JOHN BUZDOR

S.I. # 060

Memo

Special Inspection issue summary

2
S4.0

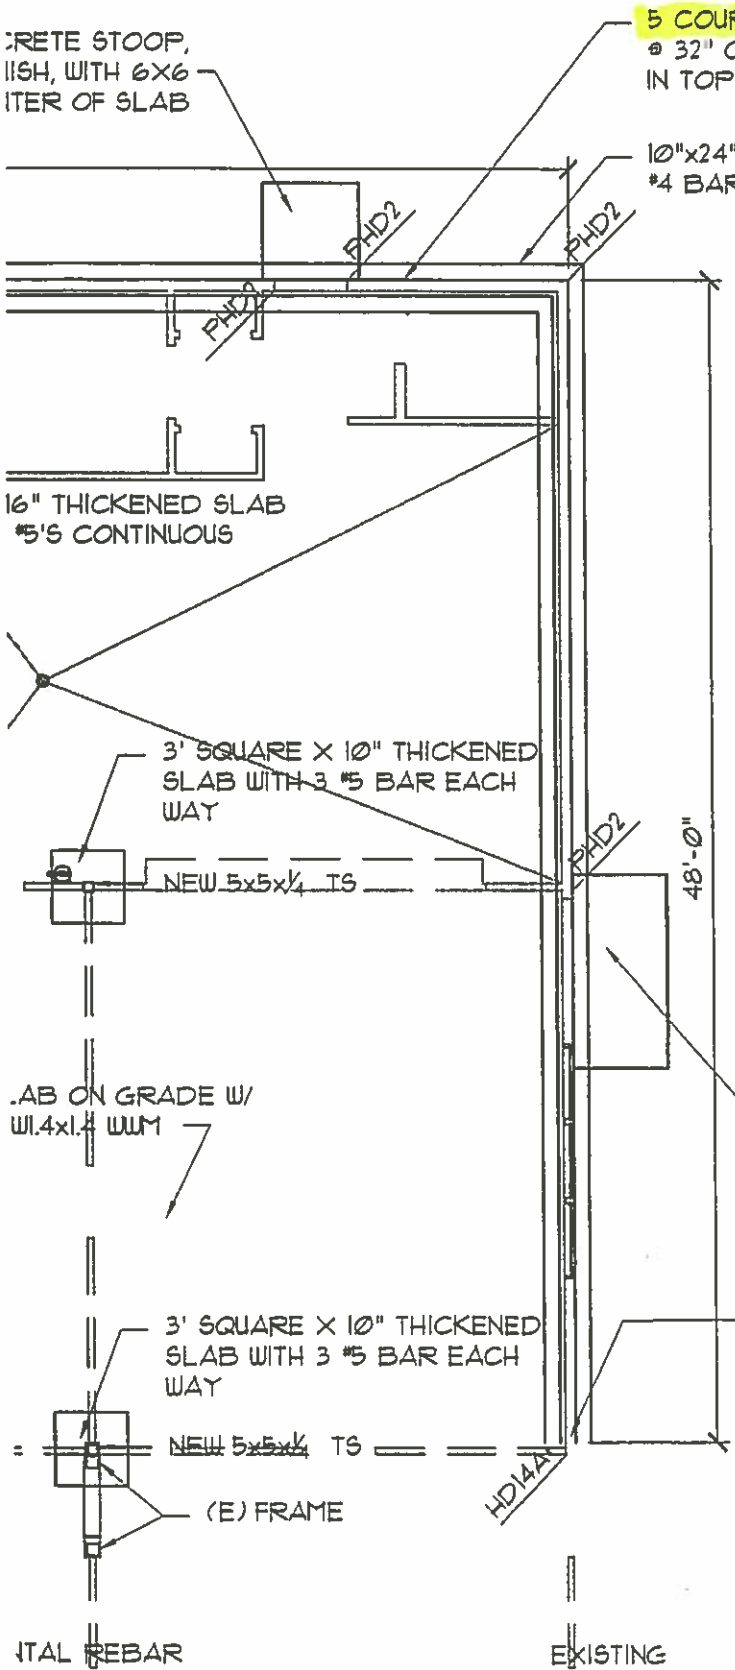
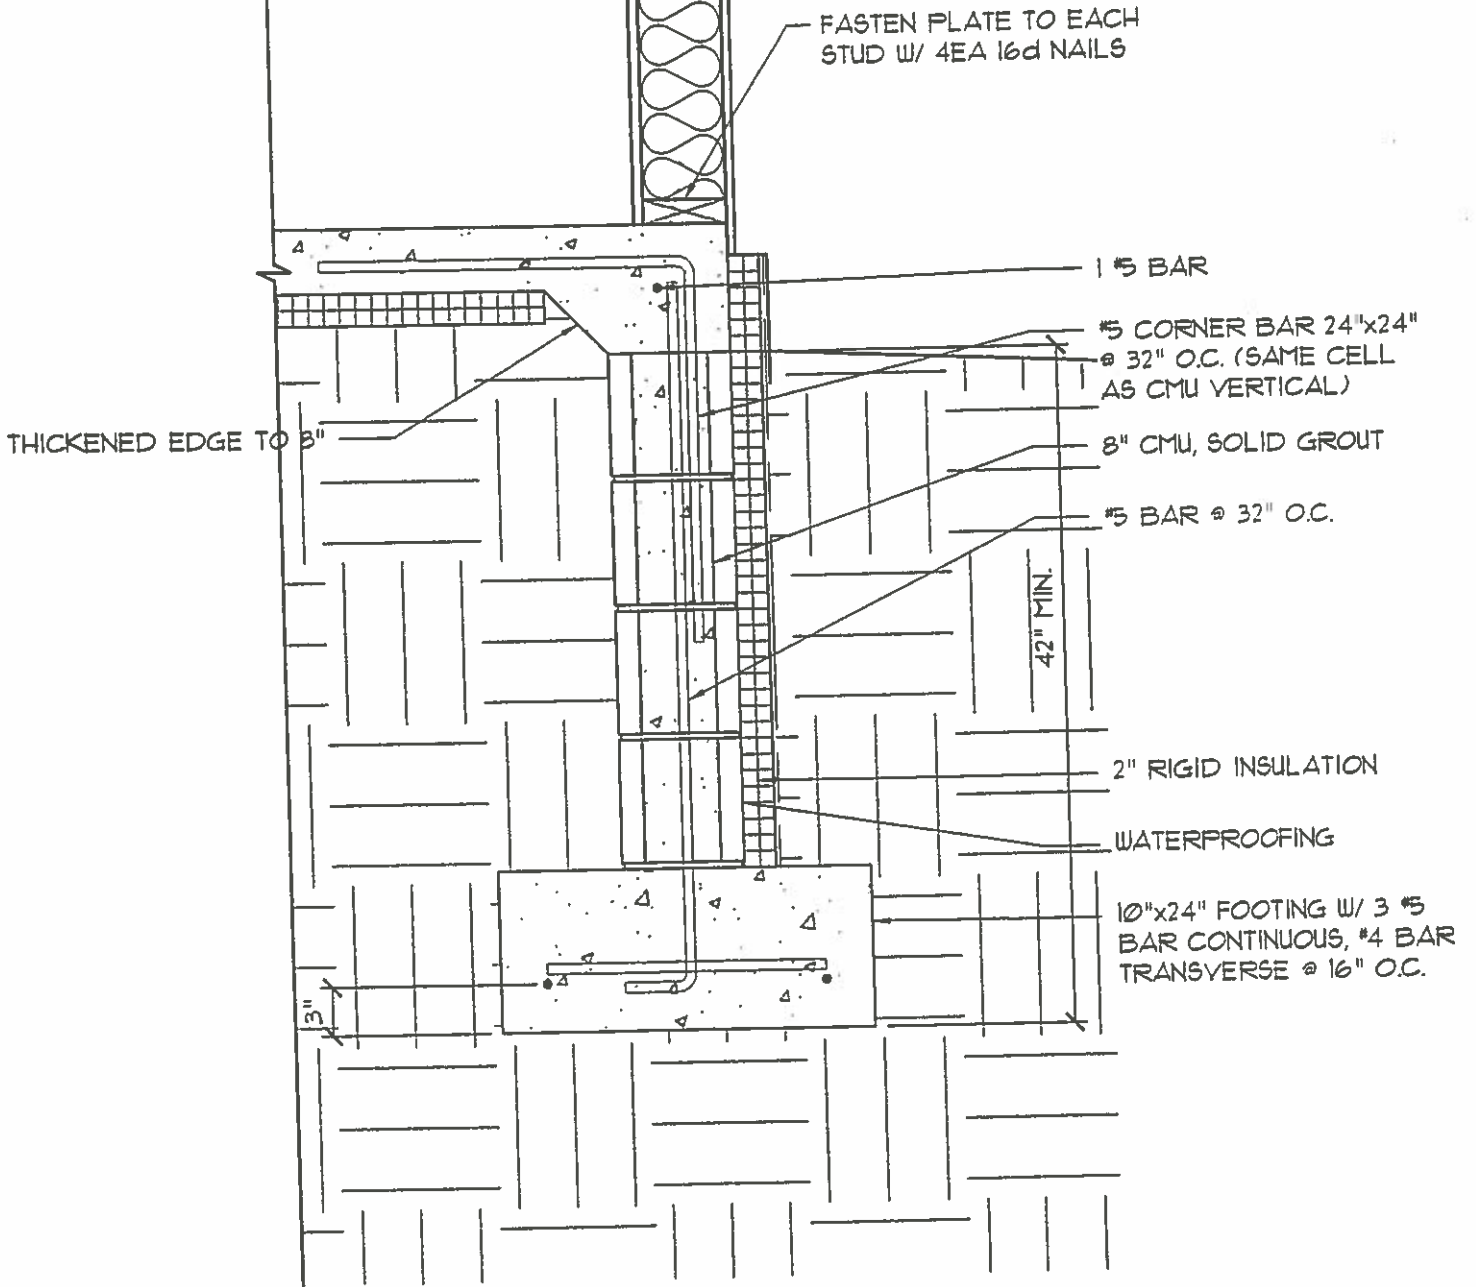
The foundation's construction did not comply with the MOA approved drawings. On a plan sheet there is a note saying the foundation wall is to be a 5 course CMU wall (see attached). But Detail 2/S4.0 (see attached) shows it to be a 4 course wall with an 8" thickened slab running over the top. There is a conflict unless the resulting wall had 5 courses of CMU with a thickened slab running over the top. Instead it was built as a 5 course wall with the slab butting into it. The slab running over the top of the wall is not equal to the slab butting into the wall.

i. provide a rebar C.O. An AS built foundation
 (5 course w/ slab dowls vs thickened
 slab shown on plans)
 Rick~
 Burdon approved contrary to plans

- 1) The plans show a thickened slab connecting to the foundation wall. Instead, a foundation consisting of five courses of block with slab dowels was provided.

Regarding the particulars of your 11/20/06 letter, the approved drawings did indeed show four courses of block and a thickened slab over top. The plans alternatively contained a note designating "five courses of block". The structural engineer agreed to either approach, contractor option, and the contractor went with five courses of block. The contractor explained the construction during my 11/11/06 inspection, and I was satisfied the work conformed to the plans. Both alternatives are essentially identical from a structural perspective. I did not recognize the need for a change order.
